663 A TEL SET	A-580201
663 B TEL SET	A-580201
USED ON	DWG

663 A TYPE TEL SET CONNECTING DIAGRAM

6S CDS A-580202

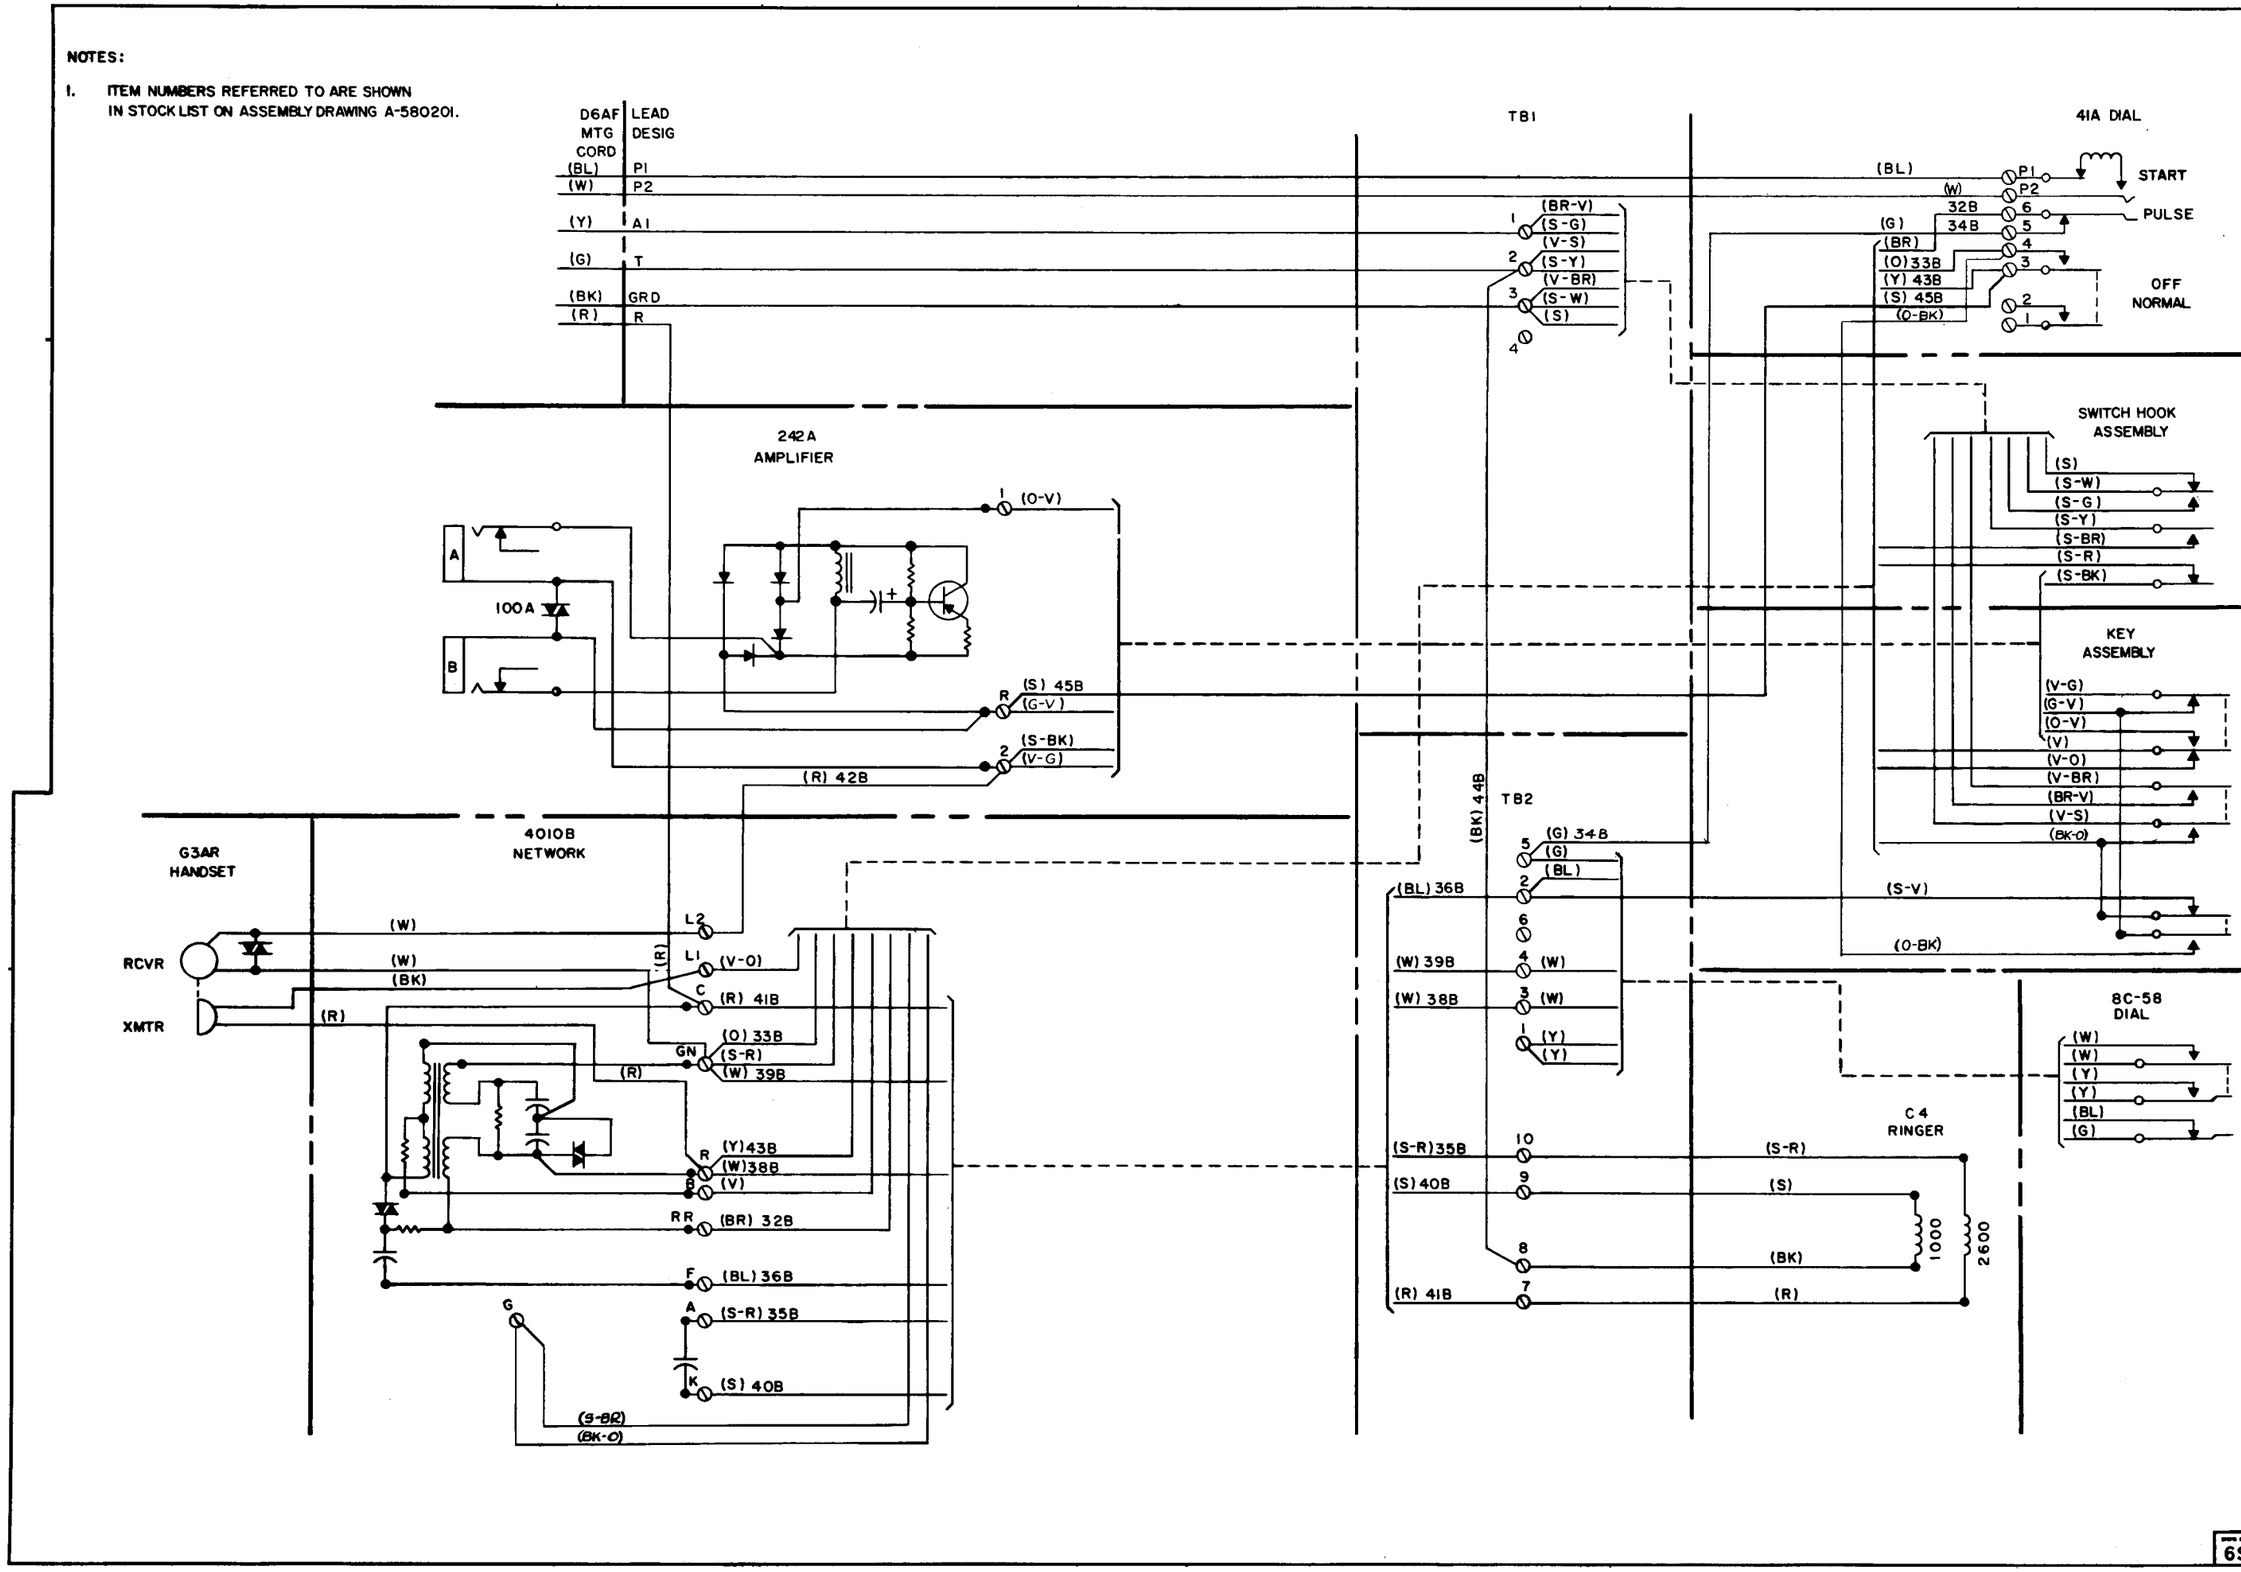
8-2-63 ISSUE-1
REMOVED: LEAD CONN T4 OF TB1 & T P2 OF 41A DIAL WAS (W) 37B.
CHANGED: D6AF WAS D6AB; (W) P2 LEAD WAS SHOWN CONN TO T4 OF TB1.

ASD 591620-D-L
2-13-64 2
ADDED: (O-BK) & (BK-O) LEADS TO KEY ASSEM.
REMOVED: STRAP WIRE FROM KEY ASSEM. BETWEEN (V-G) LEAD CONNECTION & BOTTOM CONTACT.
CHANGED: (G-V) & (V-G) LEADS CONN. TO 242A AMP. WERE INTERCHANGED; (S-BK) LEAD CONN TO TERM. S OF 4010B NET. WAS CONN. TO TERM. F OF 4010B NET
